**FINAL DRAINAGE REPORT**  
for  
**LOT 1 BLOCK 1, JOHNSON VACATION**

Falcon, Colorado

**November 18, 2022**

**PCD File No: PPR-21-067**

### DBPS BASIN MAP

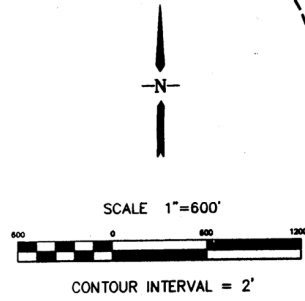
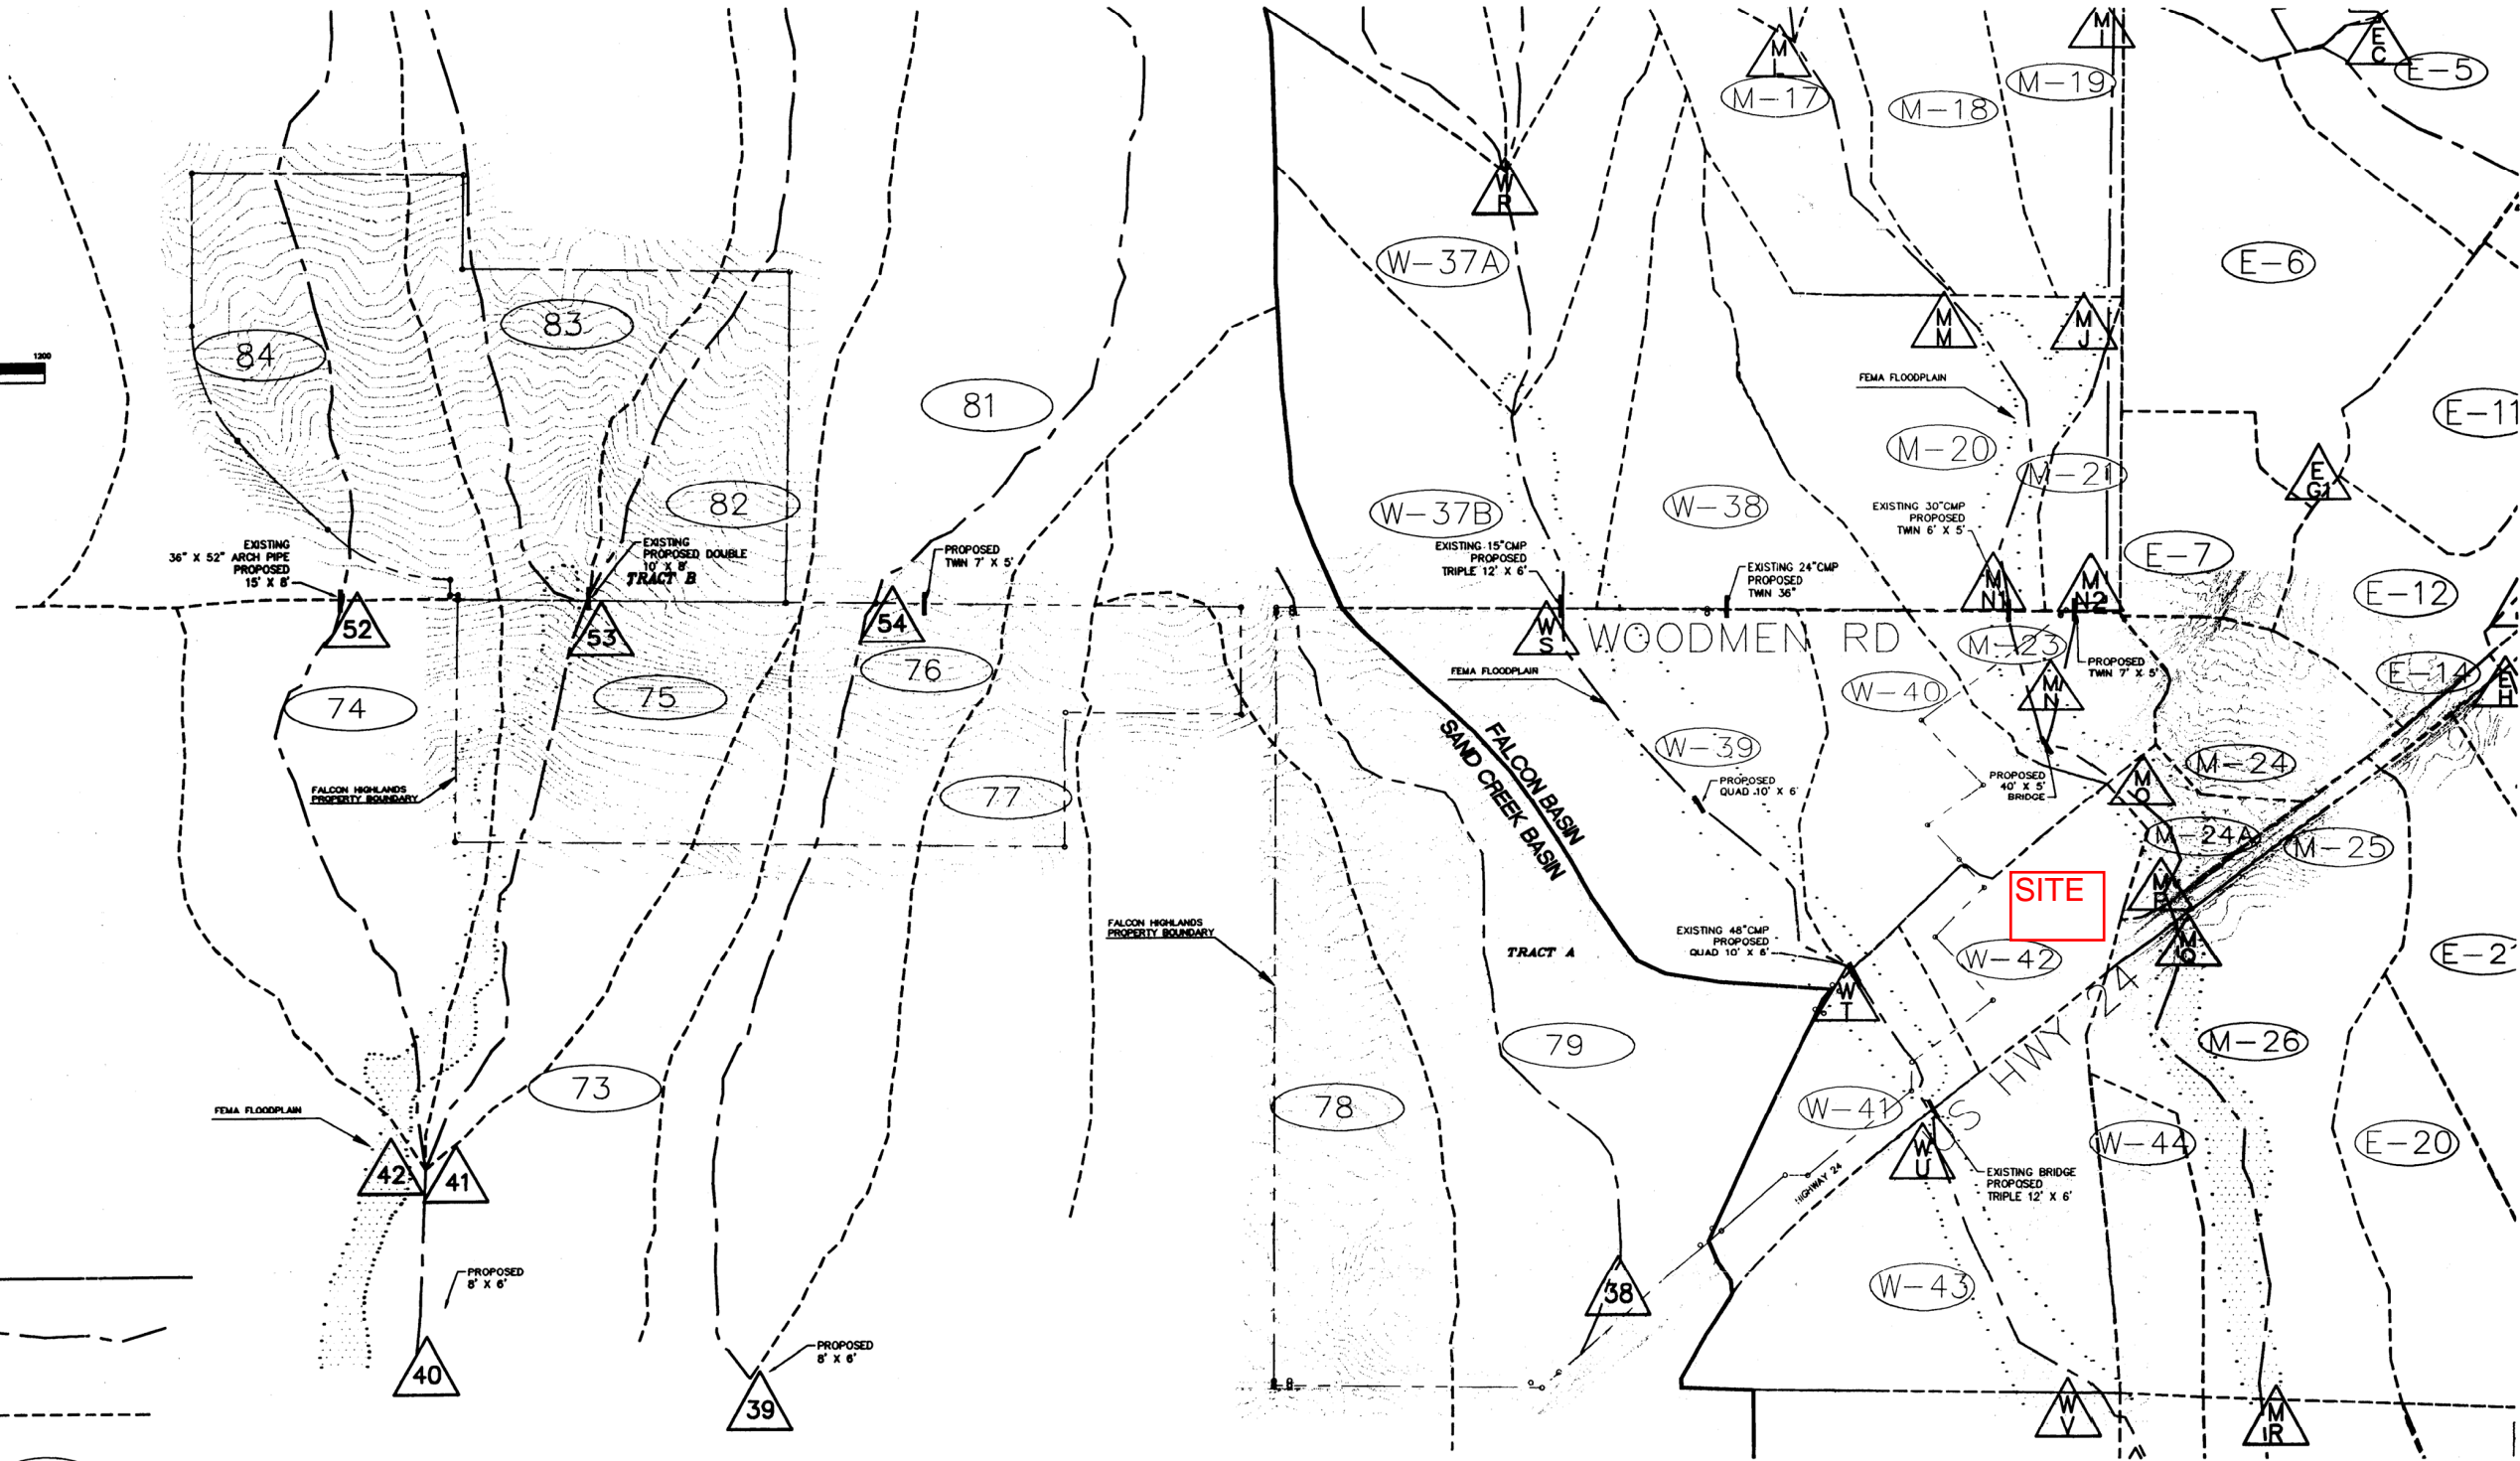
From discussions with Jeff Rice, it is believed that this site does not actually drain to Pond WU. Please review all applicable reports (DBPS, MDDP, FDR's) and provide more supporting documentation (maps, text, calcs, etc) than just this map that shows that this site drains to Pond WU.

**EXISTING DRAINAGE CONDITIONS**

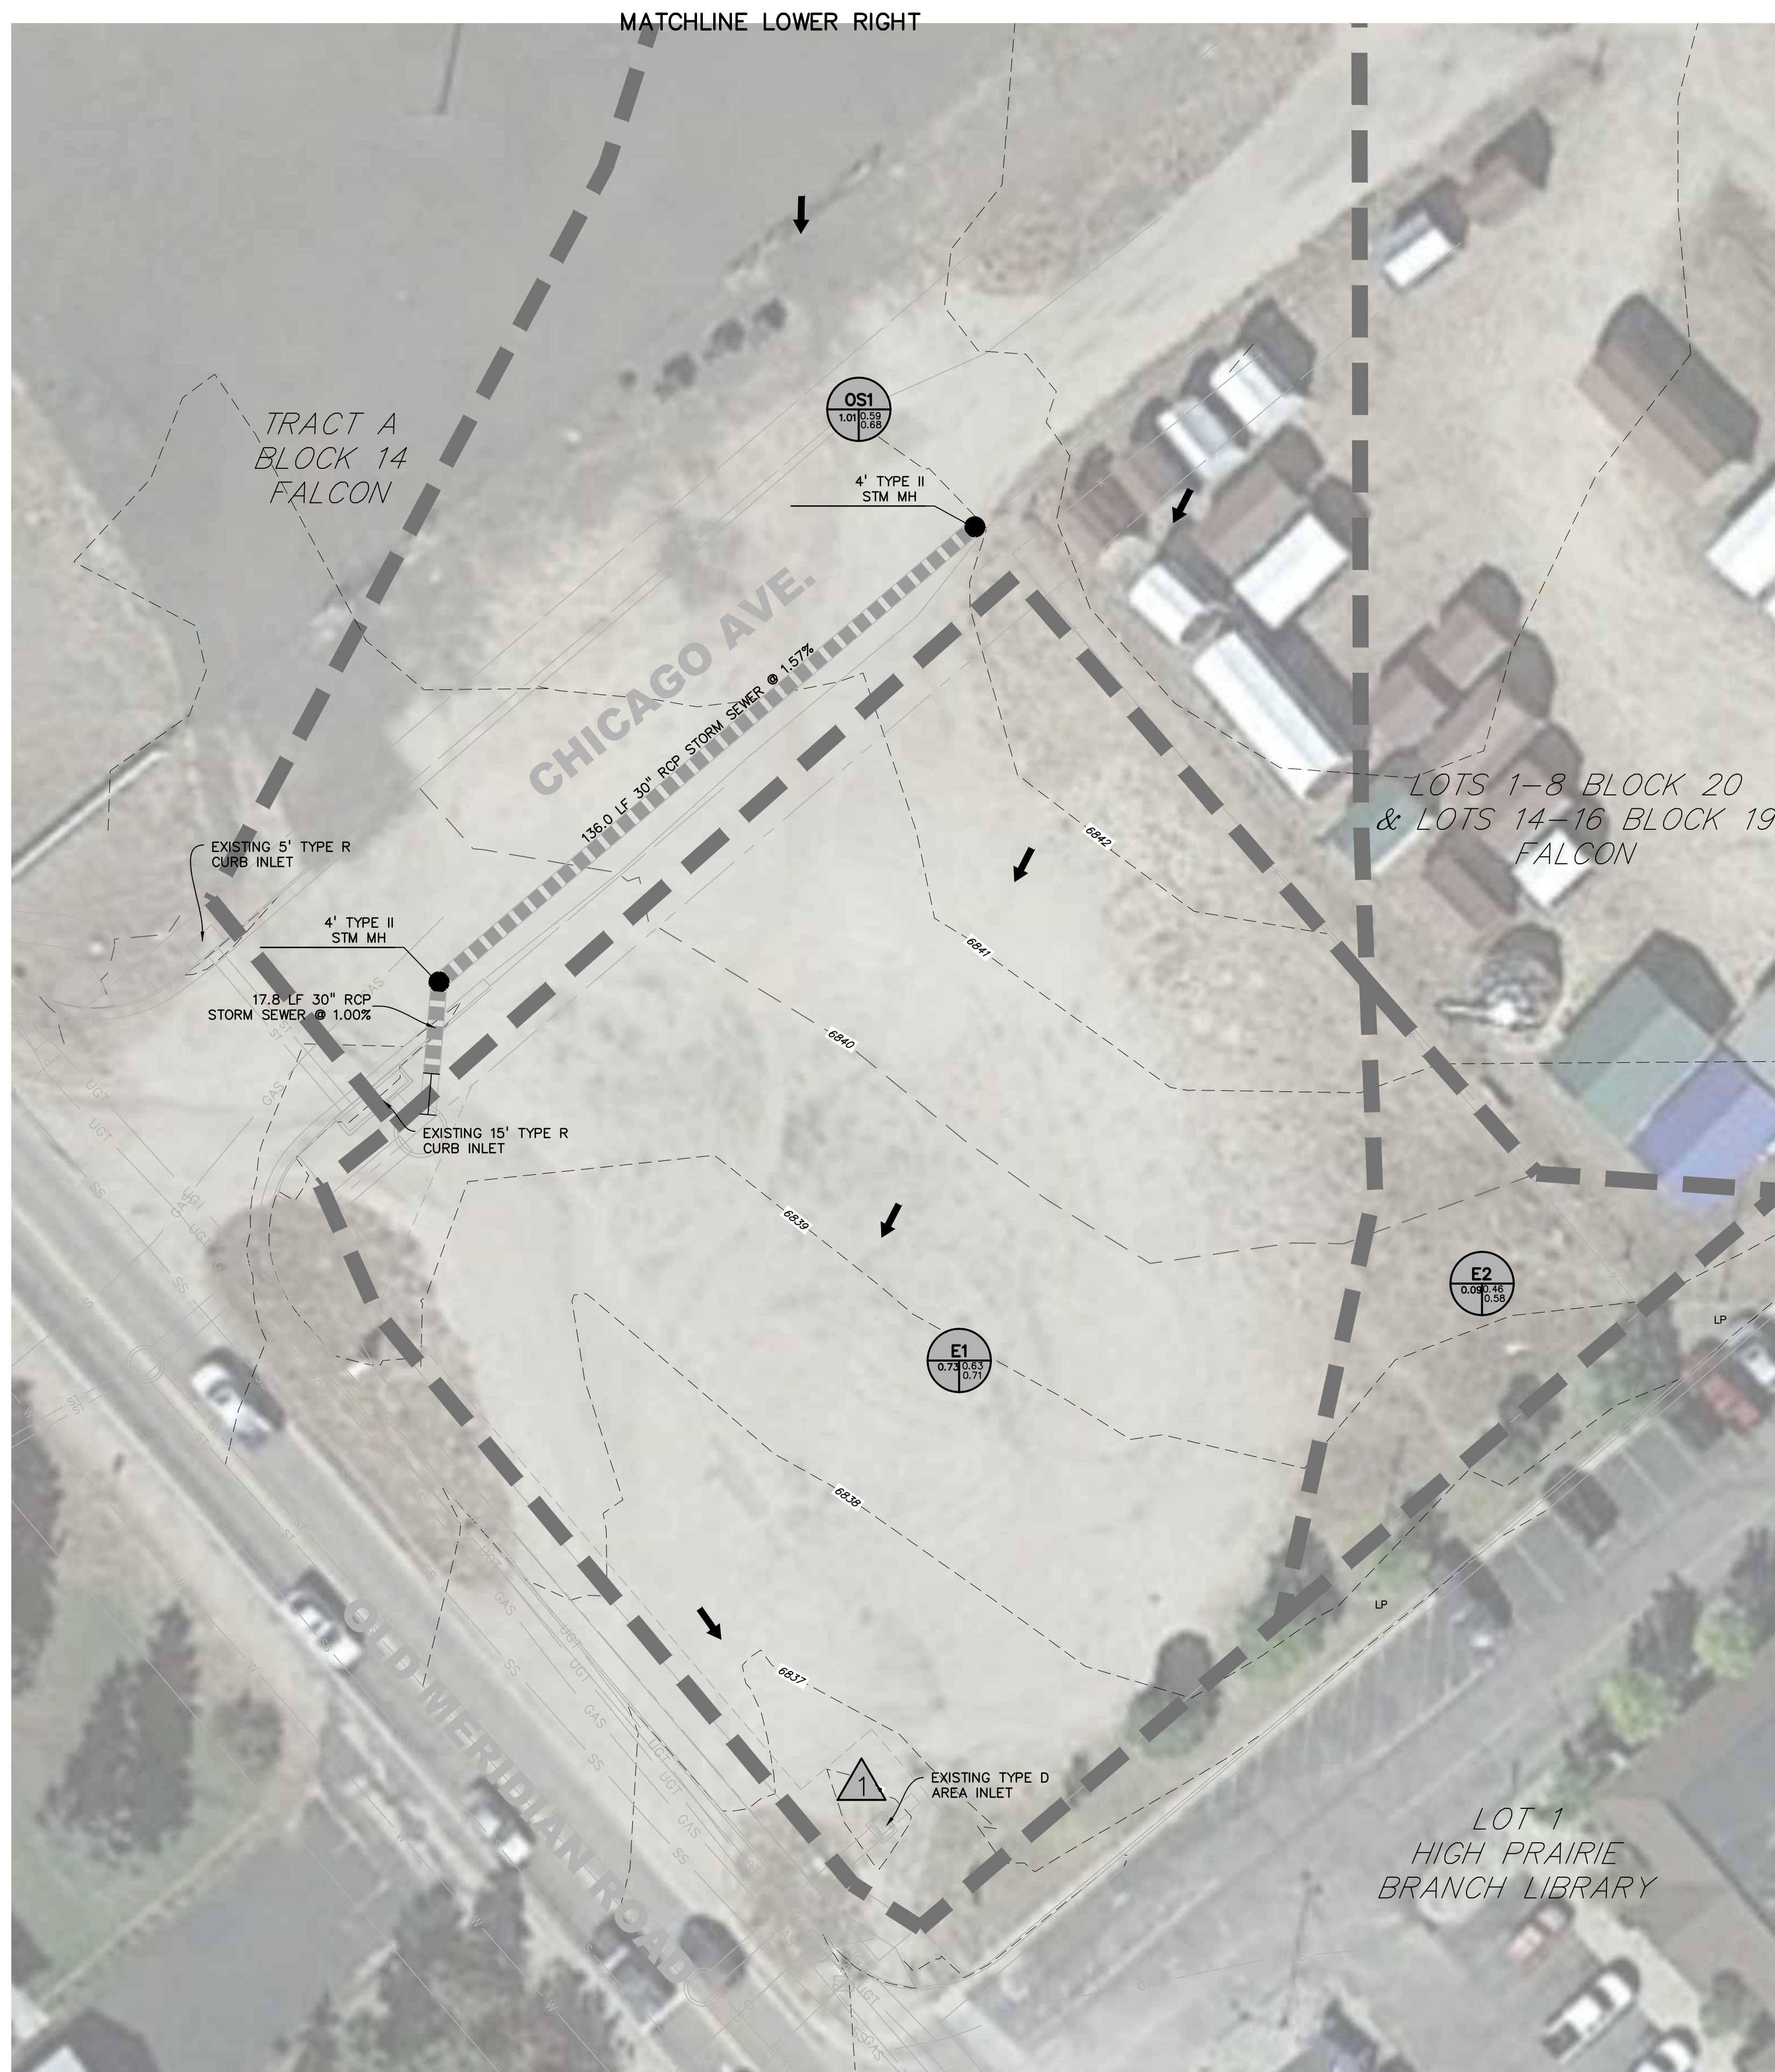
- Show runoff conveyance all the way to detention and water quality facility, whether it's onsite or offsite.
